UNITED STATES PATENT AND TRADEMARK OFFICE

APPLICATION NO.	FILING DATE	FIRST NAMED INVENTOR	ATTORNEY DOCKET NO.	CONFIRMATION NO.
10/705,597	11/10/2003	Anand Anandakumar	JA03-001	6241
28112	7590	09/28/2006	EXAMINER	
SAILE ACKERMAN LLC 28 DAVIS AVENUE POUGHKEEPSIE, NY 12603			CHAUDRY, MUJTABA M	
			ART UNIT	PAPER NUMBER
			2133

Office Action Summary	Application No. 10/705,597	Applicant(s) ANANDAKUMAR, ANAND	
	Examiner Mujtaba K. Chaudry	Art Unit 2133

DETAILED ACTION

**FIG.9**

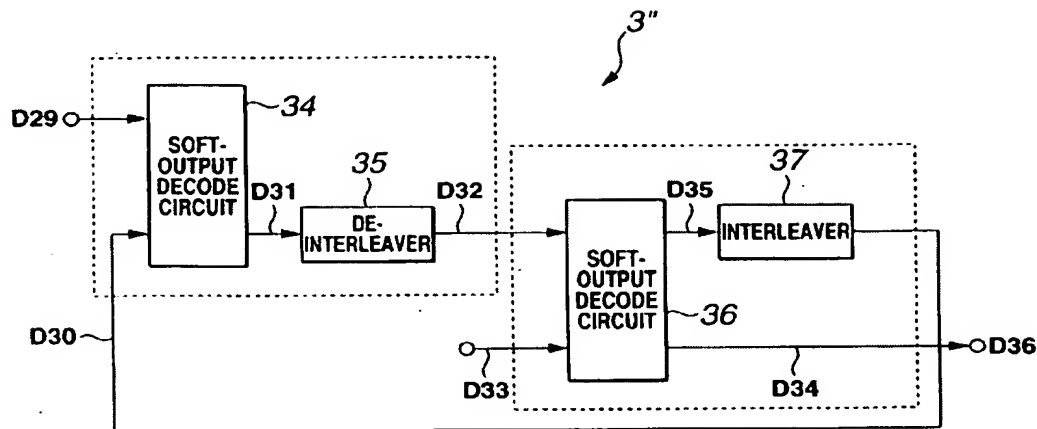
As per claim 1, Miyauchi substantially teaches a decoder for a communication system (i.e., Figure 1), the decoder comprising: a first decoder block (i.e., Figure 9, reference number 34 and paragraph 0280-0281) that receives a soft-input information bit for decoding and calculates a probability estimate for the soft-input information bit; a second decoder block (i.e., Figure 9, reference number 36 and paragraph 0280-0284) configured to receive and process the probability estimate of the soft-input information bit; and a decision module adapted to receive the processed soft-input information and to generate hard-decision output information (i.e., paragraph 0909).

Miyauchi does not explicitly teach to perform modulo arithmetic operations as stated in the present application.
